***MODIFICATION REQUEST:
S75W modification of the UNSW Medical
Sciences (Wallace Wurth) Building,
Kensington Campus (MP09_0075 MOD 1)***

Director-General's
Environmental Assessment Report
Section 75W of the
Environmental Planning and Assessment Act 1979

November 2011

Figure 4: Proposed modifications, northern elevations East (M) & West wings

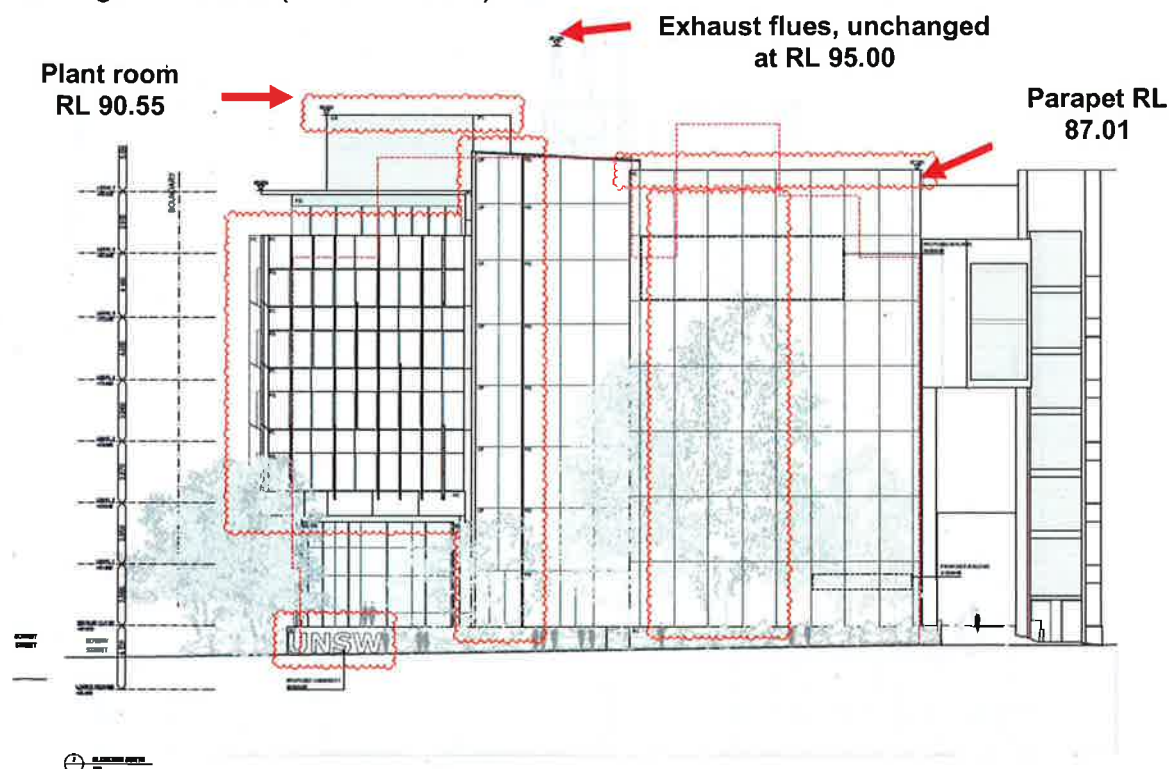
1. East (M) wing, northern façade (High Street) –
 - Substitution of approved 4 storey high horizontal aluminium louvred screen and curtain wall with a precast concrete spandrel and integrated vertical precast fins; and
 - Minor increase (0.55m) in wall height of eastern level 7 plant room. No changes are proposed to the overall building height (RL95.00 to exhaust flues).
2. West wing, northern façade (High Street) –
 - Replacement of the approved 6-storey high vertical glazed window in the existing riser of the building and external screen of louvres with precast panels; and
 - Minor 0.49m reduction in parapet height (from RL87.50 to RL87.01)

See Figure 4 below (clouded in red).

The proposed modified façade will still comprise a combination of precast concrete panels interspersed with selected accent colours, projecting bay frames, aluminium louvres and aluminium mullions/fins consistent with the approved external finishes. The façade will provide a balance between horizontal and vertical and solid and lightweight elements to create visual interest and relief.

The overall design and built form of the proposed modified building will be consistent with and complimentary to that of adjacent buildings on the site, including the new Lowy Cancer Research Building. The proposed modification will generally provide strong articulation and reinforcement to the High Street corner and enhance the streetscape and visual character.

The proposal is also generally consistent with the built form and character envisaged by the *University of NSW, Kensington Campus Development Control Plan (2007)*. Accordingly, the proposed modification is recommended for approval.

Figure 5: Proposed trees to be retained (green) and removed (red).

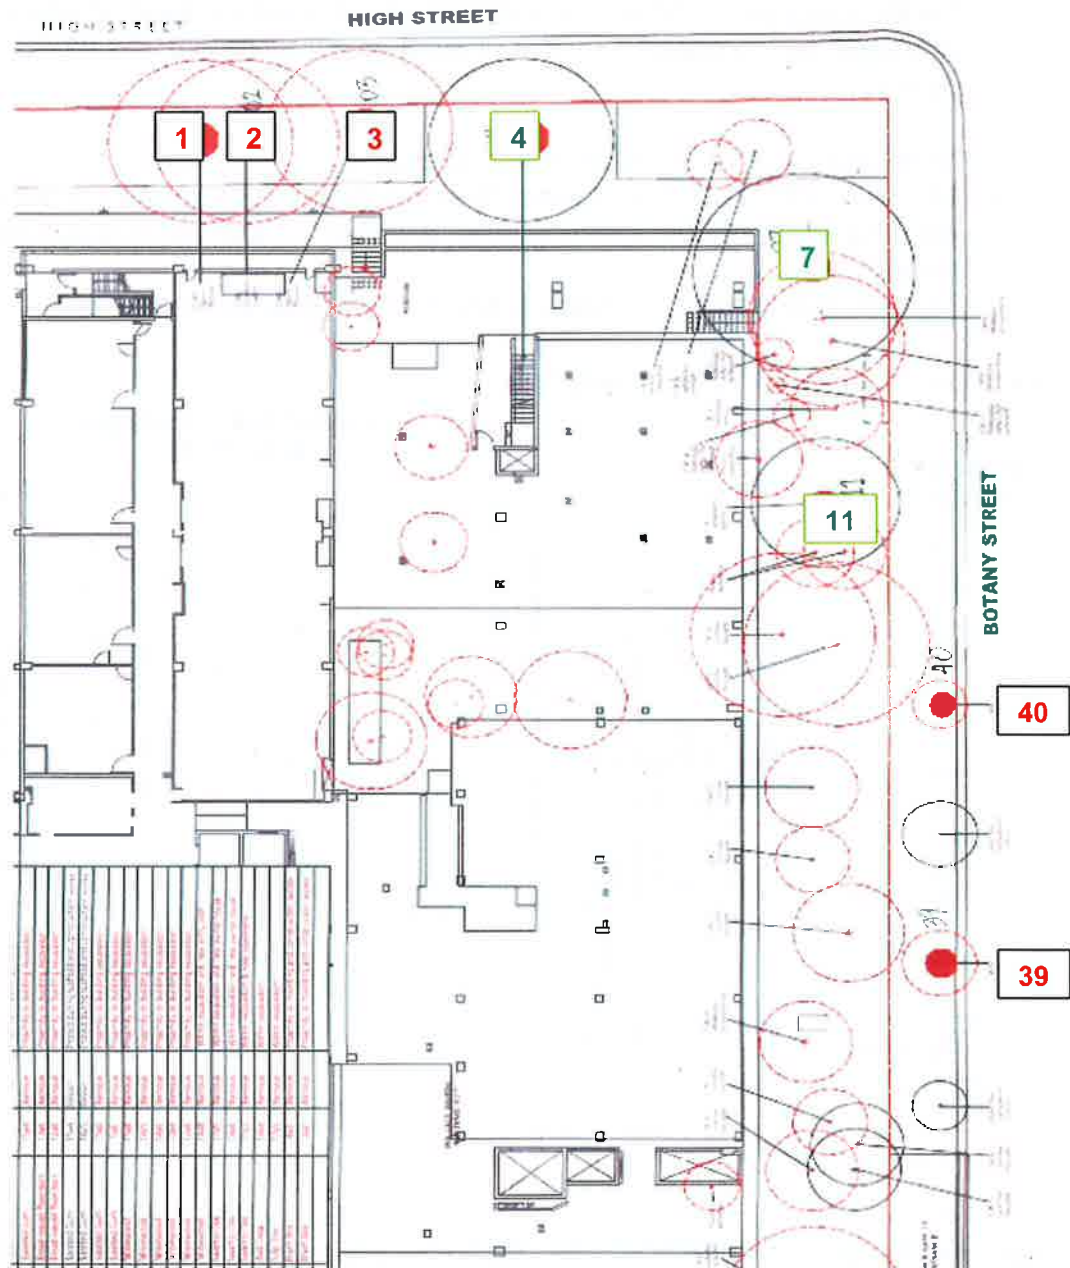
3. Modifications to tree retention/removal along Botany and High Streets (Figure 5):
- Remove Trees 1, 3 - *Agonis flexuosa* (Willow Myrtles) and 2 - *Eucalyptus scoparia* (Wallangara White Gum) on the High Street frontage (approved to be retained);
 - Retain Tree 4 - *Podocarpus falcatus* (Brown Pine) - on the High Street frontage (approved for removal); and
 - Retain Trees 7 and 11 - *Calodendron capense* (Cape Chestnuts) – on the Botany Street frontage (approved for removal).
 - Remove Trees 39 and 40 (semi-mature brush boxes) on Council's Botany Street footpath (not specified in the approval to be retained or removed).

The proponent's reasons for the removal of trees 1, 2 and 3 (**Figure 5**) are:

- Tree 2 has shown significant decline in health due to natural senescence and pest infestations since the original inspections and reports 12 months ago; and
- Upon finalisation of the building design, it became apparent that trees 1 and 3 would be heavily impacted due to the proximity of works.

Due to the height of the proposed building, removal of trees 1, 2 and 3 may potentially impact upon the environmental amenity of the area. However, this will be partially offset by the retention of trees 4, 7 and 11 (**Figure 5**), particularly due to their prominent location (on the corner of High and Botany Streets), and proposed supplementary planting included in the approved landscape works.

The proponent's arborist's report stated that any works undertaken on the root plates of trees 1, 2 and 3 may further compromise their health and stability, with the high volume of pedestrian and vehicular traffic on High Street to the north a major safety concern if the trees were retained. Accordingly, the Department has no objections to the removal of trees 1, 2 and 3.

The proponent's reasons for the retention of trees 4, 7 and 11 are based on independent discussions it initiated with the Royal Botanic Gardens and Domain Trust (RBG&DT). The RBG&DT advised that trees 4, 7 and 11 were rare, particularly tree 11, an extremely rare, white flowering variety of the species.

The proponent's reasons for the removal of trees 39 and 40 are to accommodate construction access and a widened footpath. The Department considers those trees could be selectively removed and replaced (at the proponent's cost) given their small size.

The proposed modifications to tree retention/removal are considered minor and will result in no net change to the number of trees affected by the approved project and

will result in the retention of one tree of a rare species. Accordingly, the Department recommends modification of Conditions B13.
